# Memo

**To:** The Atherton Planning Commission  
**From:** Sally D Bentz-Dalton, Town Arborist  
**CC:** Sean Manalo, Associate Planner  
**Date:** 9/17/24  
**Re:** Tree Protection Zone (TPZ) Exception 251 Selby Lane

Tree #16

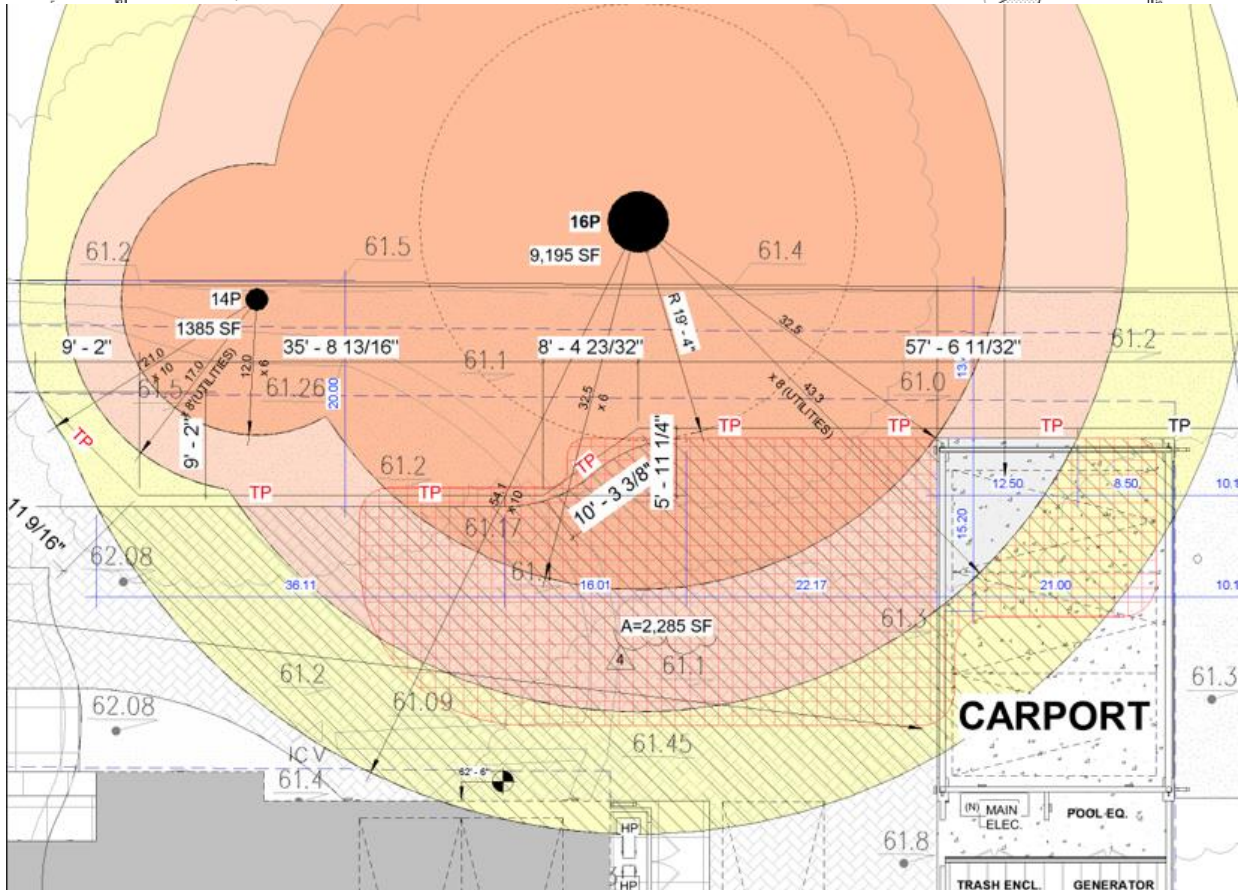
The applicant is proposing a new driveway location and carport which requires 2 TPZ exception requests for a neighbor's redwood tree.

On July 29<sup>th</sup>, 2024, exploratory trenching along the proposed driveway and the carport by Kielty Arborist Services. They found one large root, 3.8" in diameter. The arborist states that the root can remain because it falls under the 6" excavation for the geogrid. The combined percentage of root zone impacts including the driveway work is 26.5%. Impacts are expected to be minor.

### **Request #1- Tree #16 – Driveway – 3.5x TPZ-**

Tree #16 is a large redwood on the neighbor's property. Per Town policy TPZ zones are required for neighbor's trees 15' from the property line. There was an existing driveway however this driveway location is a new driveway. Per code a new driveway location is required to be 8x away. The applicant is proposing a driveway 3.5x or 19' away from the redwood tree.

### **Request #2- Tree #16 – Carport – 6x TPZ-**

Tree #16 is a large redwood on the neighbor's property. Per Town policy TPZ zones are required for neighbor's trees 15' from the property line. The applicant is requesting a 6x TPZ, 32.5' away for the carport. There wasn't a structure there previously and the old pool house was 48' away.

A carport is required to be 10x away with a staff exception down to 8x. The applicant is asking for 6x. This is the critical root zone and in this area per the top map no structures in this area. Per Matheny and Clark this tree would have a TPZ of 8x. The carport is yet another area that will impact this side of the redwood tree that didn't have an impact previously.

I can recommend the below two requests based on neighbor's approval, that the 1 root can be protected and not removed, and no other significant roots were found, that the driveway uses Biaxial Geogrid and Mr. Kielty's recommendations are followed, because there were no other alternative locations with no impacts to heritage trees and less than 26.5% of roots will be affected.

- Letter from neighbor
- 3.8" diameter root is protected and not removed
- Required to be installed and **shown on G&D plans** - Biaxial Geogrid (Tensar BX-1100) as an underlayment to be placed on top of the parent soil. Minor rough surface grading not to exceed more than 6". Biaxial Geogrid (Tensar BX-1100 or equivalent) to be placed on the soil with only hand-tamped compaction preparation used. The geogrid material is to be used as a subgrade layer below aggregate (rock/gravel) and will need to be pinned down to the soil. It is a stiff synthetic permeable material consisting of sets of tensile ribs pre-tensioned in two directions to allow the pinning down of surrounding soil, stone, or other material. Edging needed is recommended to be supported above ground by individual stakes.

- **Show on quarterly report** - One month before construction is to start the neighboring Redwood trees along the driveway to be irrigated from the proposed driveway side of the property using 300 gallons of clean water as mitigation for the minor impacts. The remaining trees all have large, landscaped areas between the trees and the driveway where minor supplemental irrigation should be installed. Oak trees #10 and #11 should be irrigated at the proposed driveway edge every other week for one year using 40 gallons of water at a time per tree. Deep water fertilizing with Nutriroot is required. After one year irrigation near the oaks is recommended to be suspended. Redwood tree #16 is to be irrigated every other week during the dry season with 40 gallons of clean water within the

- **Show on G&D and quarterly report** - The entire proposed foundation when within 10x the diameter of the tree is required to be excavated by hand in combination with hand tools such as an air knife, rotary hammer with clay spade attachment, or shovels, while under the direct supervision of the Project Arborist. All roots encountered within the foundation area measuring 1.5" in diameter or larger are recommended to be retained for the Project Arborist to inspect before being cleanly cut. Once inspected and documented, the roots will need to be cleanly cut using a hand saw or loppers. Cut root ends on the tree side are recommended to be painted with a tree pruning sealer/grafting compound then covered by 3 layers of wetted-down burlap to help avoid root desiccation. The contractor shall wet down the burlap daily while exposed. The area between the tree and the foundation (tree protection zone) to be irrigated every other week during the dry season until the top foot of the soil is saturated. This will act as a mitigation measure for the minor impacts. This work will be required to be documented by the town of Atherton with a letter sent to the city arborist.

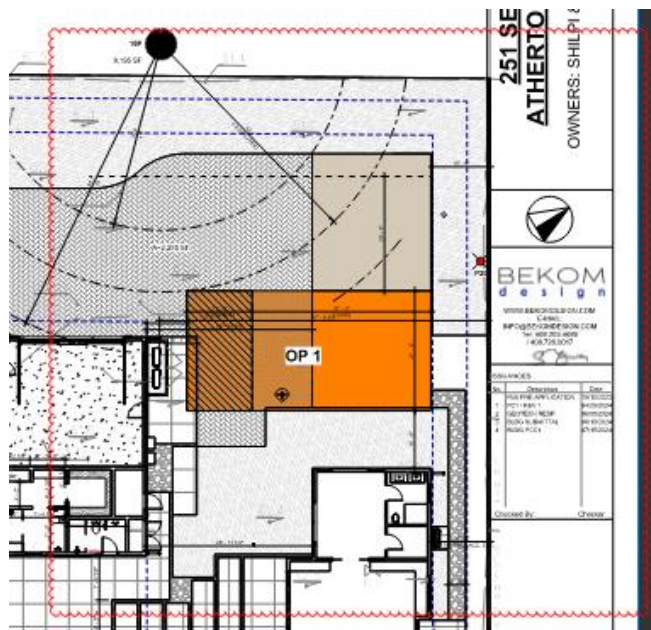
I asked the applicant to show alternative locations for the carport:

Per the applicant: The property's front setback for accessory structure is 90', which reduces the significantly the available space to place the Carport closer to the entrance.

Option 1: Allows the structure to be outside the x8 area, however, it is not possible to keep the 8' distance from the main house. Also, the driveway will have to be extended, encroaching even more into the TPZ for T16. Please note that the minimum car backing driveway area shall be at least 20'.

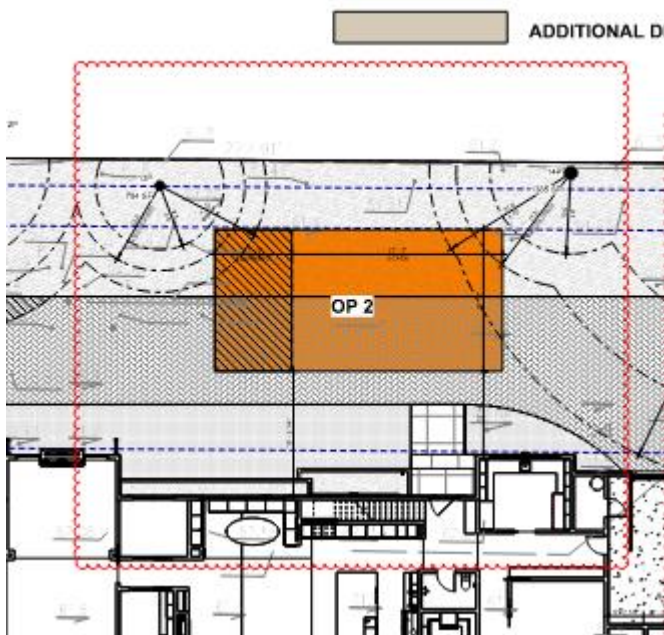
Option2: this location does not allow the access to the main house garage. Furthermore, it encroaches in both T13 and T14; and it does not give enough space for 'car backing' (only 18').

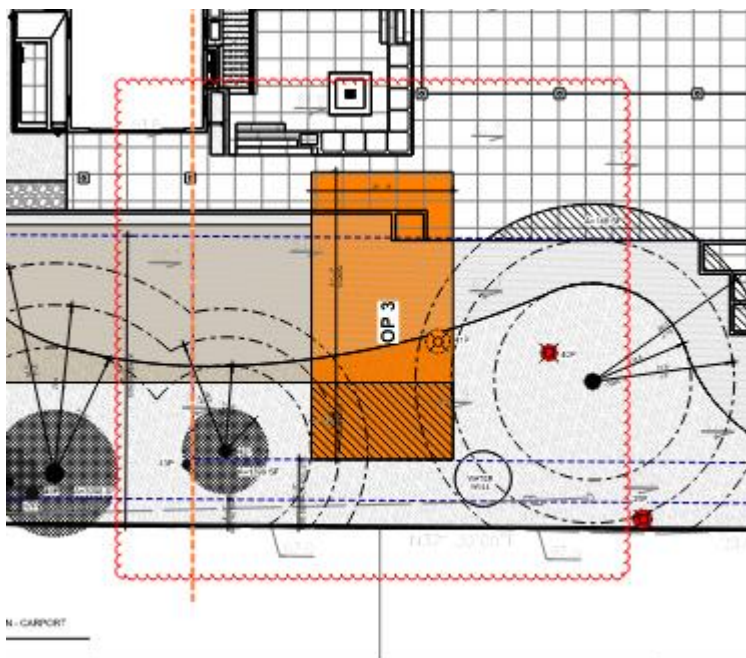
Option 3: Requires an extensive additional driveway area, which encroaches into the TPZs of T42, T45, T47, and T52; and the carport structure encroaches into the TPZ of T39 and T42. We found that the proposed location is one that best complements the Site Plan accessibility, keeps the best compliance with the Town's zoning rules and disturbs the least any other TPZs in the property.
